A complete set of current "Selectric" Typewriter CEMs consists of "Selectric" Combined Service Information booklet, CEMs starting on page 1, and the Technical Information Index.

416 SERVICE INFORMATION

SUBJECT: CHECK PAWL, SPRING, STUD AND TAB KEYLEVER — REDESIGNED

(Figure 1)

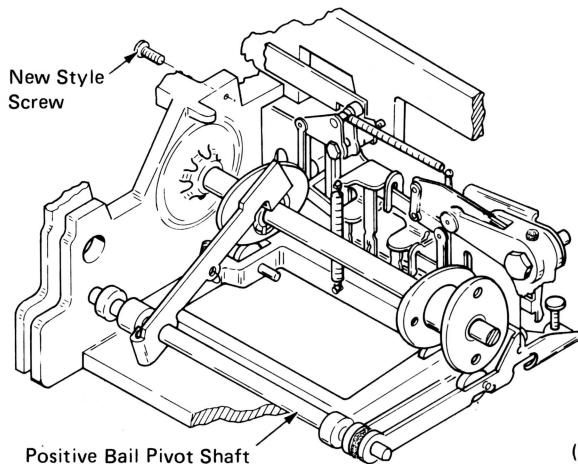
The cycle clutch check pawl, stud and spring has been designed to improve cycle shaft cam stop location (Figure 1).

(Figure 2)

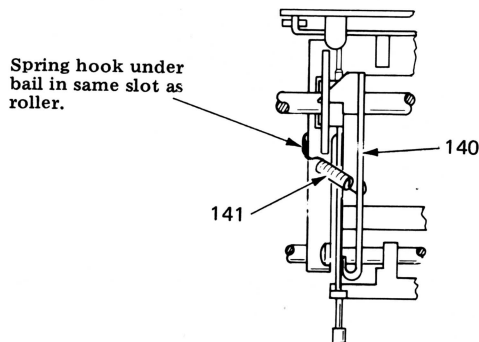
The new pawl (23-140) is now mounted on the positive bail pivot shaft (23-118). The screw (23-142) replaces the studs (23-417, 423). The studs (23-417, 423) will remain available for replacement on old level machines (Figure 2).

(Figure 3)

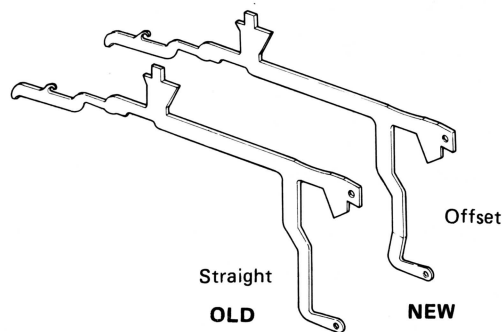
The pawl is spring loaded to the left by spring (23-141), and is connected to the positive bail as shown in Figure 3.

Figure 1

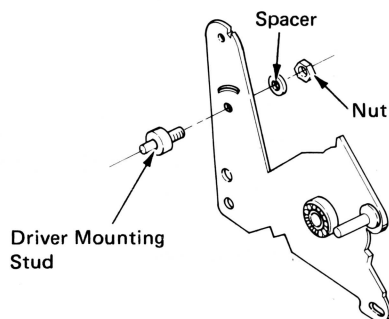
Backspace failures due to a broken driver mounting stud may be corrected using the backspace driver mounting stud B/M.

1. Remove driver mounting stud from backplate by tapping lightly.
2. Remove the "C" clip, washer, driver, pitch cam (disconnect pitch cable), and pitch cam spring from the stud.
3. Insert the new stud (24-155) in the pitch cam spring, pitch cam (connect pitch cable) and driver.
4. Install washer and "C" clip on the front of the stud.
5. Install stud through the hole in the backplate and secure with washer and nut (Figure 1).

Figure 1

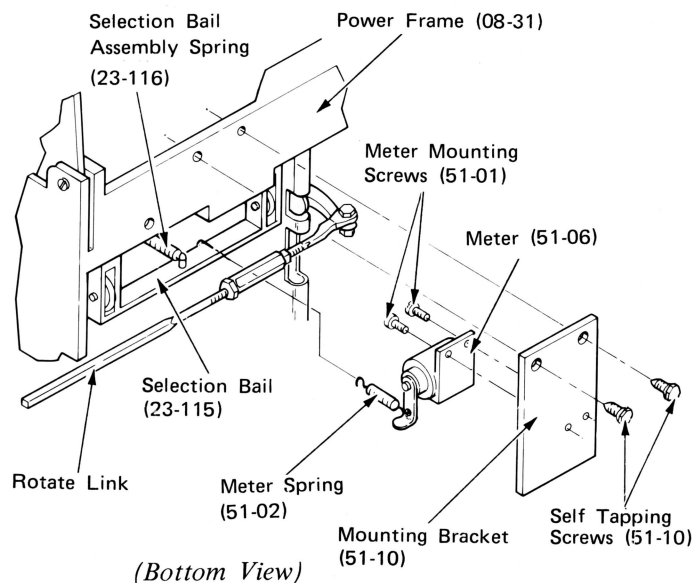
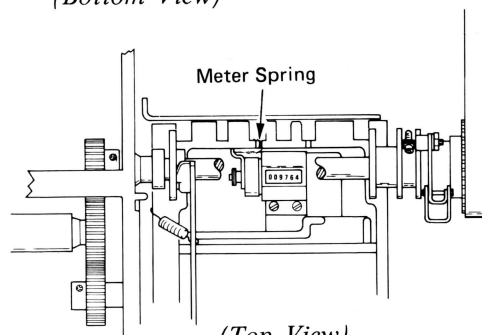
The "Selectric" stroke counter has been redesigned to mount on the bottom of the power frame as illustrated in Figure 1. A new field installable B/M (51-9) is available which contains the hardware and counter. The only ratio available for new installations is 120:1.

Adjust the bracket or the counter front to rear so that the arm gets enough motion from the positive bail to advance the counter.

Figure 1B

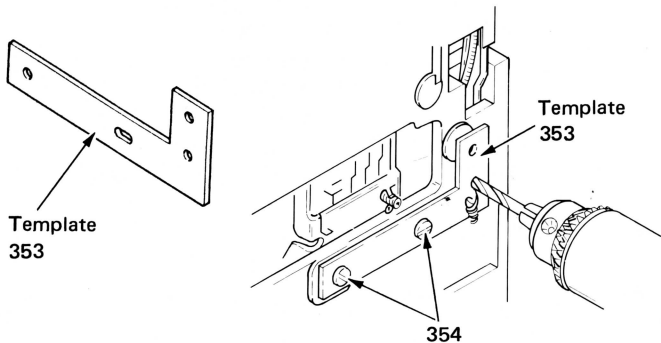
PURPOSE:
To reduce operational shaft flex, and improve reliability of the index mechanism on applications such as continuous multiple copy forms, pin feed, and 45/48 tooth OCR.

1. Attach the drilling template (Figure 1A) to the machine frame as shown in Figure 1B. Drill the two holes with a No. 22 drill bit (P/N 450265) and remove template.

Figure 2B

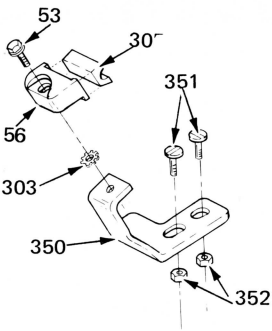
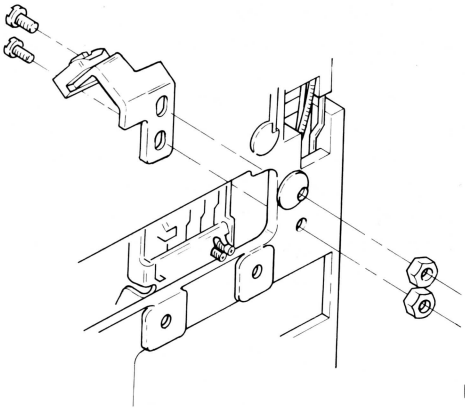
2. Assemble and install the operational shaft support bracket asm. as shown below (Figures 2A and B).

3. Position the operational support bracket front-to-rear so the front of the bracket evenly contacts the power frame as shown in APM, frame 134.
4. Perform adjustment APM, frame 135.

Figure 1

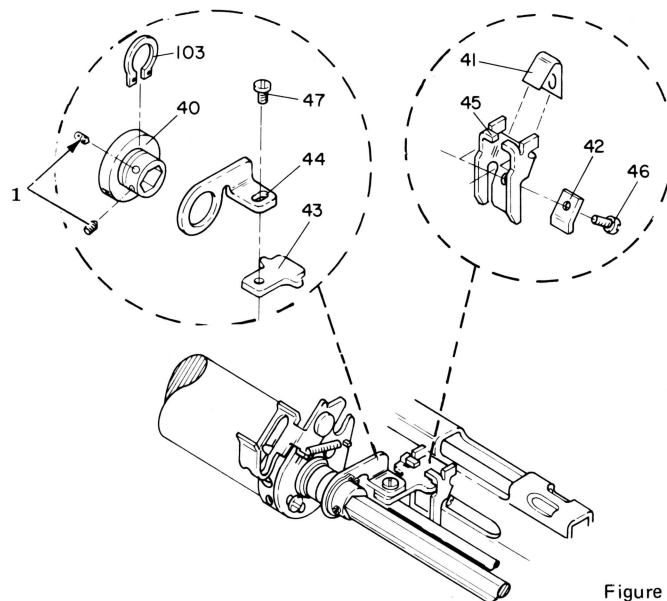
A pinfeed platen support B/M (49-50) is now available to reduce movement of the pinfeed platen caused by typehead impact. [Max. pin to pin approx. x5, 10" (254.0 mm) — x3, 9 1/2" (241.30 mm) — x1, 6" (152.40 mm)]

Install the support B/M (49-50) on the right side of the platen (Figure 1) as described below:

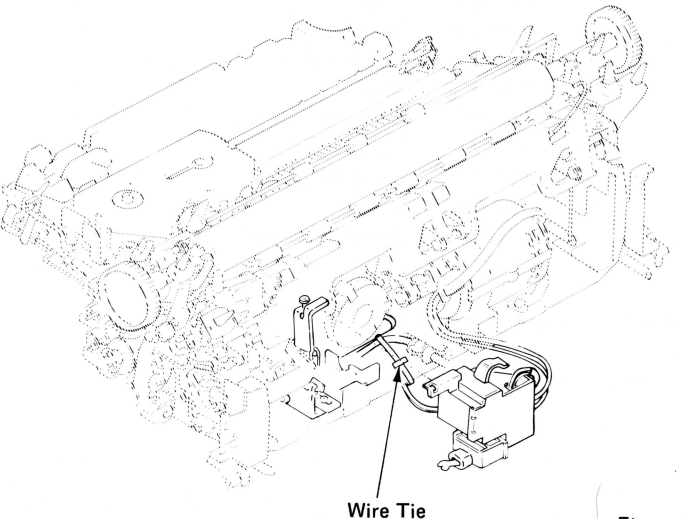
PURPOSE:
PRECAUTION: The motor shell could become live (i.e., line voltage present on the motor shell) on dual pitch "Selectric" IIIs manufactured prior to the S/Ns listed below. The length of the line cord from the white strain relief to the transformer may be excessive. The added length can allow the cord to contact the motor pulley/shaft. This may wear the line cord insulation, resulting in the shell becoming live.

1. Unplug the line cord and remove the covers.
2. Check for damage to the line cord insulation in the area indicated and replace it if damage is evident.
3. Install wire tie (11-606) as shown in Figure 1.
4. Reapply power and check for proper machine operation.

Figure 1

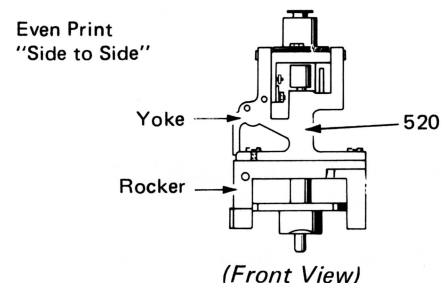
If the platen height eccentrics do not provide sufficient adjustment range, one of the following corrective actions may be used.

"Selectric" and "Selectric" II with eccentric overthrow: Install B/M (22-314). This B/M includes new LH and RH platen supports (22-280, 291) which have been modified to allow the platen to be adjusted lower. The parts are color coded a gold tone for identification. Individual P/Ns for the LH and RH supports will not be made available. If replacement of the supports does not solve the problem, the yoke must be replaced.

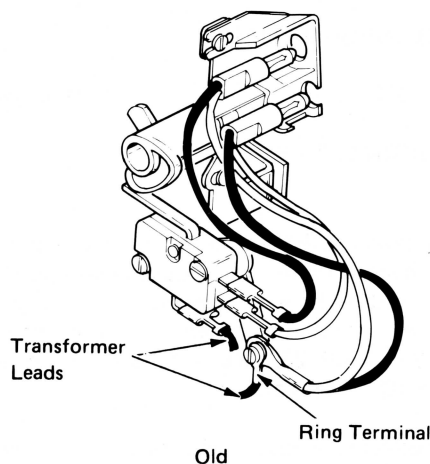
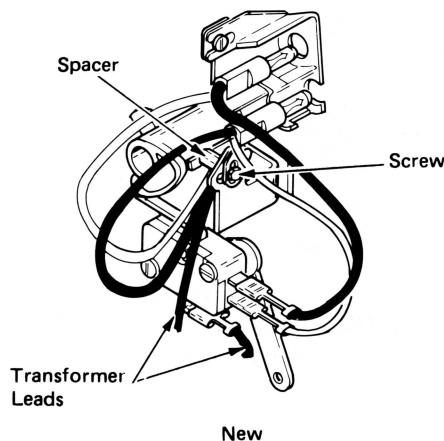
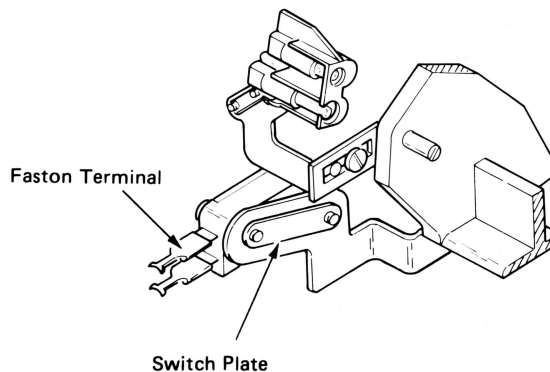
The method of connecting the secondary wiring at the margin light switch plate (10-109) has also been changed. Figure 1 shows the old method of connection and Figure 2 shows the new. The switch plate will be redesigned as illustrated in Figure 3. The old plate will be used until stock is depleted but the wires will be connected as illustrated in Figure 2.

If a transformer motor is used as a replacement part, the new method of wiring (Figure 2) must be used. It is not necessary to change the wire connections on machines with the previous transformer (11-603).

Figure 1

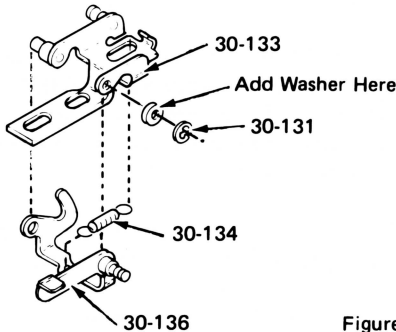
If experiencing problems in lifting the top cover (30-151) on sound machines, check for excessive side-to-side motion of the hood latch on the RH hood bracket (30-133). The top cover latch (30-136) may have slipped off the RH side of the bracket (30-133) and jammed the cover. Washer (P/N 1091220) has been used in the plant to eliminate the problem and can be used if needed in the field. Install washer as shown in Figure 1.

Figure 1

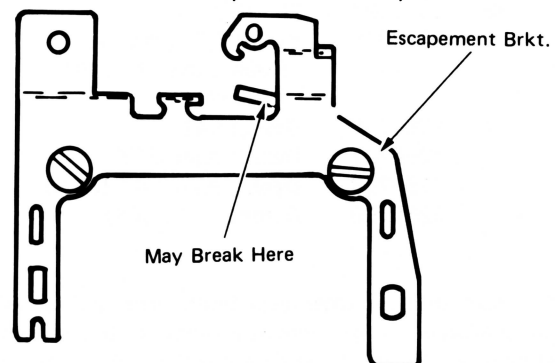
The tab torque bar back up lug on the escapement bracket may break when formed (Figure 1).

If this condition occurs replace the escapement bracket.

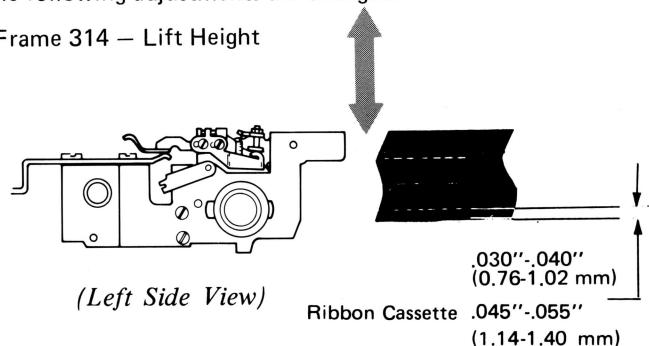
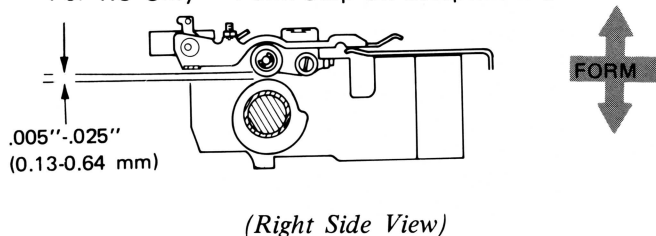
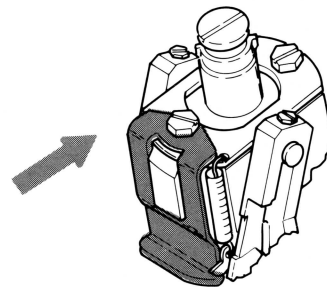
The following adjustments are changed:

Frame 314 — Lift Height

Frame 315 — Lift Arm Stop (Ribbon Cassette)

Tape Deflector — Adjust the deflector against the tilt ring.

Figure 1

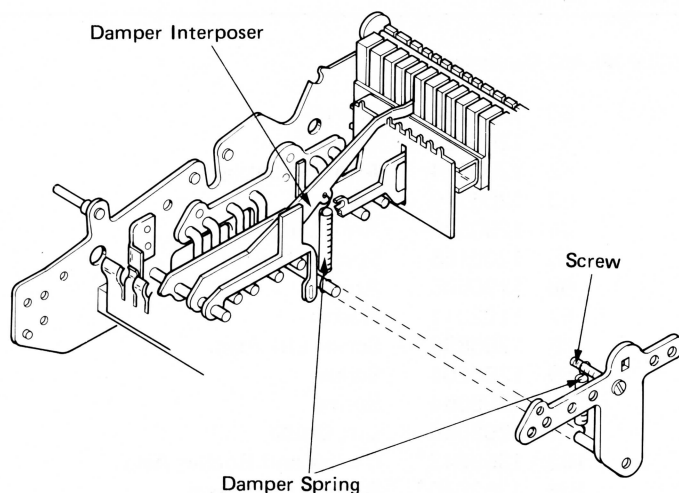
The cycle clutch bail leaf spring (21-240) has been replaced with coil springs on both sides of the key board. This change was made in order to maintain a more reliable adjustment of the cycle clutch latch pawl to keeper on the assembly lines. It will also allow the touch to be distributed more evenly across the keyboard.

The LH spring (21-210) is connected to an interposer (21-113) that has been added to the LH side of the keyboard (Figure 1). The right and left damper springs can be installed in keyboards in the field by ordering the interposer, screw, and springs. On the RH side replace the center screw in the plate with the longer screw that was ordered and attach the spring. The center leaf spring will remain available.

Figure 1

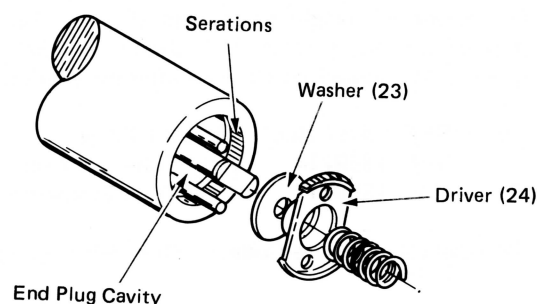
Some machines were manufactured with the potential of preventing the platen driver from fully engaging the platen. This may be caused by either an interference between the cavity in the platen end plug and the washer (12-23) — fig. 1, or small pieces of plastic end plug material that may become lodged between the driver (12-24) and the end plug serrations. If experiencing this condition, clean out the platen end plug and replace the existing washer with the current smaller diameter washer PN1359915.

Figure 1

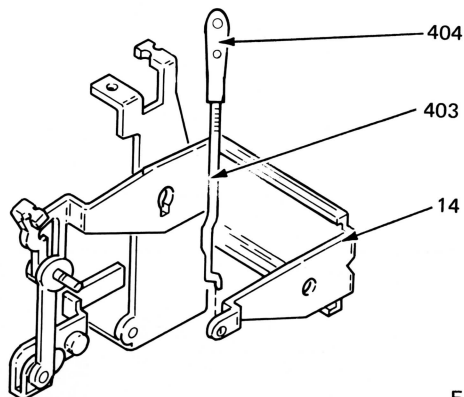
The lower end of the index link (20-403) has been changed to improve reliability. The new link utilizes an offset in place of the permanently mounted clevis. The new link may be installed by first removing the trigger restore spring (07-41). Install the offset end of the link as shown in figure 1. Then attach the clevis to the link from the top of the machine.

Figure 1

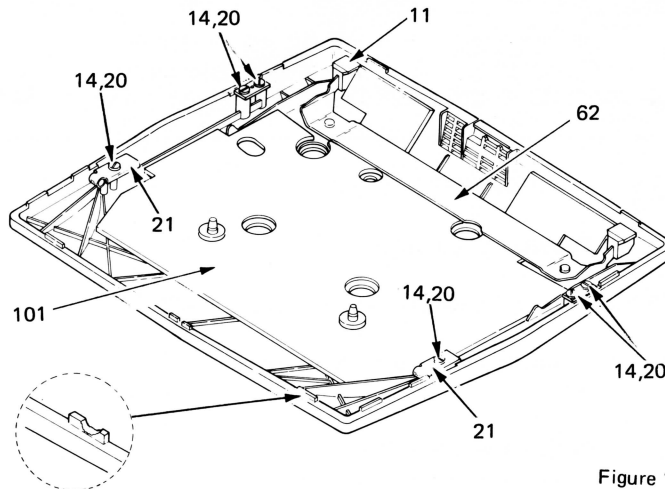
The metal bottom cover will remain available. The plastic bottom cover is not recommended for use with the modified government motor.

Figure 1

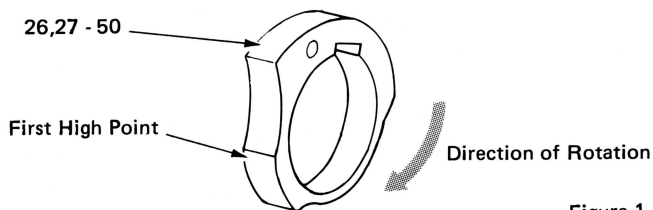
Defective correction feed cams can be replaced without removing the ribbon plate assembly by using steps 1 thru 9 (exclude step 2) of the print sleeve removal procedure in the Service Manual.

Figure 1

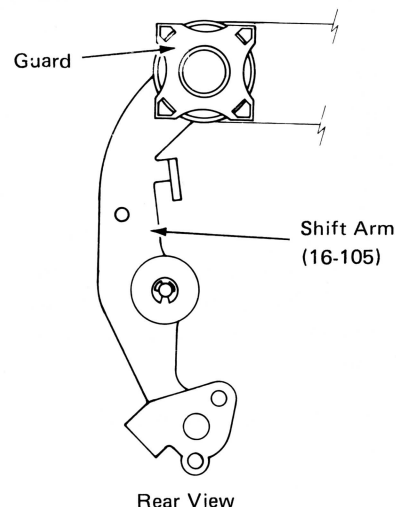
When experiencing repeated rotate tape replacement caused by the tape becoming disengaged from the shift arm pulley, install the Mag Card velocity tape guard (25-34; P/N 1457036). Prior to installing the guard, ensure that a machine malfunction is not causing the tape problem. Install the guard as shown in figure 1.

Figure 1

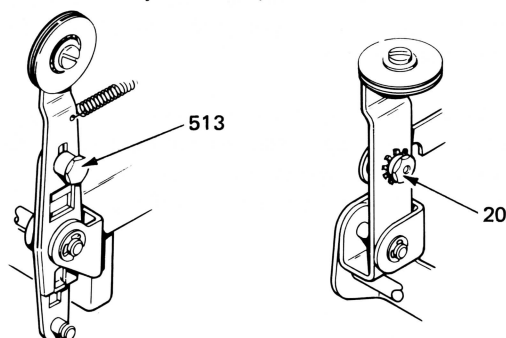
Manufacturing has redesigned the rotate arm screw (23-513) and the tilt arm nut (23-20) for the purpose of using an automated selection adjustment system (Fig 1).

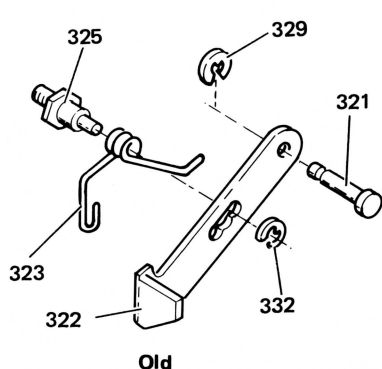
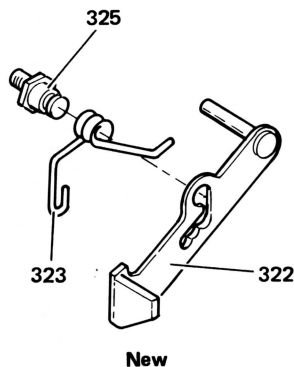
The selector cam lever (20-322) and stud (20-321) are now one piece. Additional stability is provided by the selector cam lever (20-322) interlocking with the adjustable stud (20-325). The tension spring (20-323) was modified to accommodate the adjustable stud (20-325). "C" clips (20-329) and (20-332) are not required with new level parts.

Figure 1

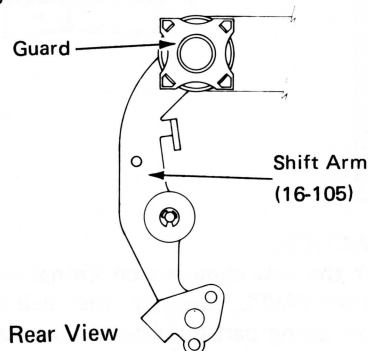
To reduce repeated rotate tape replacement caused by the tape becoming disengaged from the shift arm pulley, the Mag Card velocity tape guard (25-34; P/N 1457036). may be installed. Prior to installing the guard, ensure that a machine malfunction is not causing the tape problem. Install the guard as shown in figure 1.

NOTE: Due to a tolerance build-up of the related parts (shift pulley, rotate tape and velocity guard), a binding condition may occur on some machines. Reducing the length of the velocity guard tips by sanding, filing, etc., will reduce the binding condition.

Figure 2

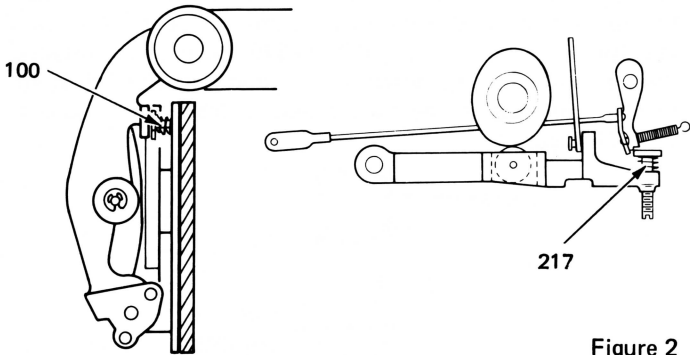
Compression springs were also designed to replace the shift arm stop screw lock nut (16-100) and the negative bail adjusting screw lock nut (23-217, Fig 2). However, due to manufacturing problems, the use of the compression springs has been discontinued.

A limited number of machines have reached the field with compression springs that may allow the stop screw(s) to move. If experiencing problems with varying selection adjustments, install the appropriate lock nut (16-100) or (23-217) to correct this condition.

Figure 1

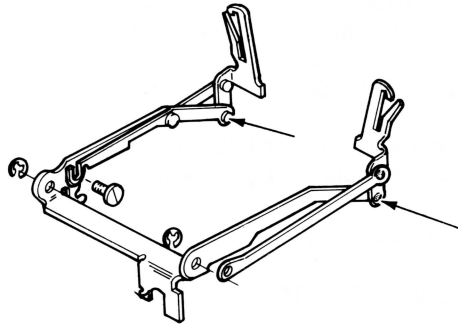
A number of machines were manufactured with defective fabric ribbon lift guide (13-37) rivets (Fig. 1). The rivet hardness and assembly method were changed to reduce breakage. If experiencing ribbon lift failures, check for either a loose or broken rivet and replace the lift guide assembly as necessary.

Figure 1

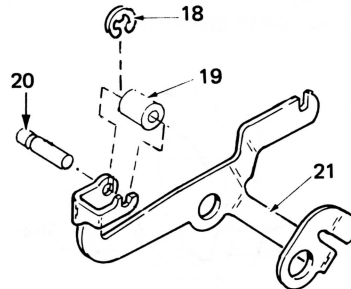
A B/M is now available to convert the 54 tooth solid roller detent (CEM 473) to 27 tooth indexing without changing the detent assembly. The B/M contains a roller (20-19) and shaft (20-20) that can be substituted for the solid roller. All parts necessary to complete the conversion are contained in the B/M.

Figure 1

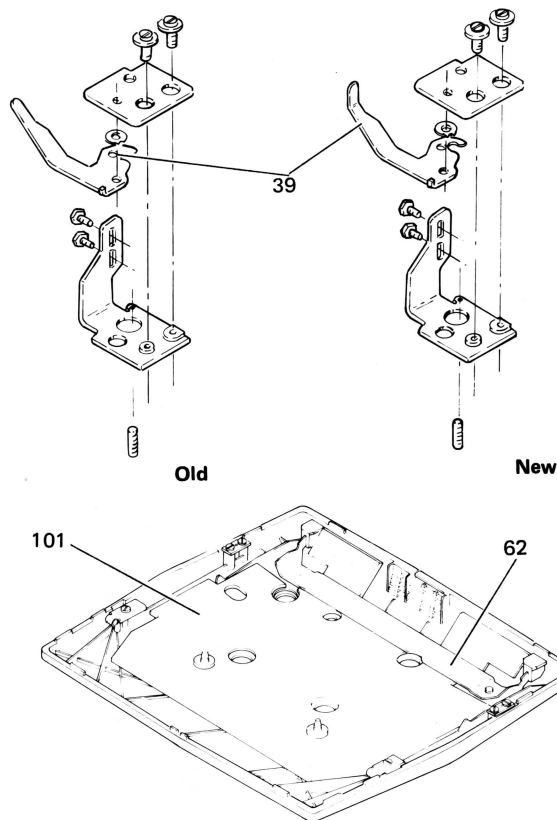
The IBM Personal Typewriter is now being manufactured with a plastic bottom cover. The new plastic bottom cover is interchangeable with the previous level metal bottom cover.

Figure 1

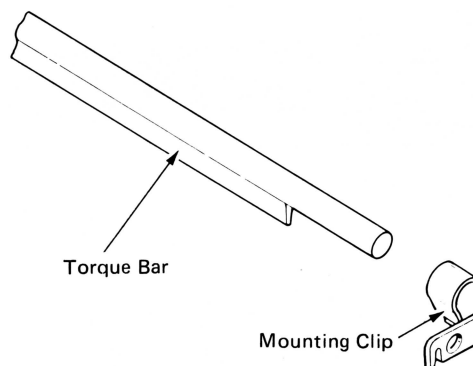
The Pre-Floating torque bar P/N 1206100 has been replaced by a B/M. The new B/M includes a Mag Card torque bar and two clips. When installing the B/M, remove the Mag Card torque bar spring anchor and install the new link mounting clip (Fig 1). A clip is included which should be used to control torque bar end play.

NOTE: After removing the Mag Card torque bar spring anchor, use a file to remove sharp edges.

Figure 1

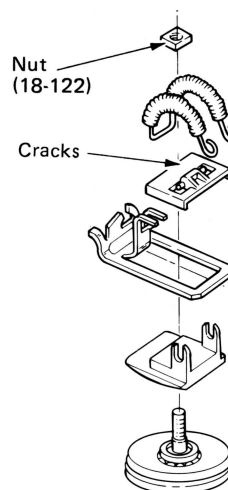
On the next service call check for cracks in the area indicated (Fig. 1). Also, examine the nut for two peen marks in the area of the pulley stud threads which are necessary to keep the nut tight. Replace the transport bracket assembly if cracks are found or the peen marks are missing.

Figure 1

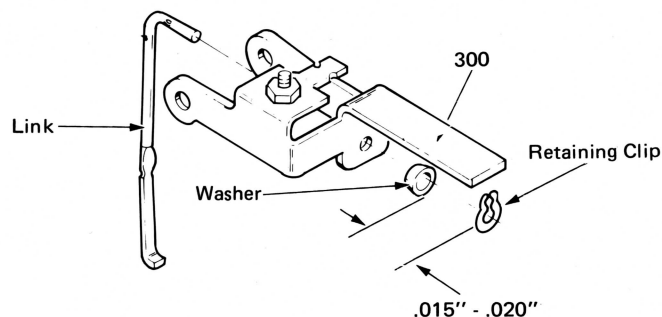
The new latch link B/M can be installed on non-rotary backspace machines (7X1, 8X1) without removing the latch assembly.

NOTE: Maintain a .015" - .20" clearance between the washer and retaining clip.
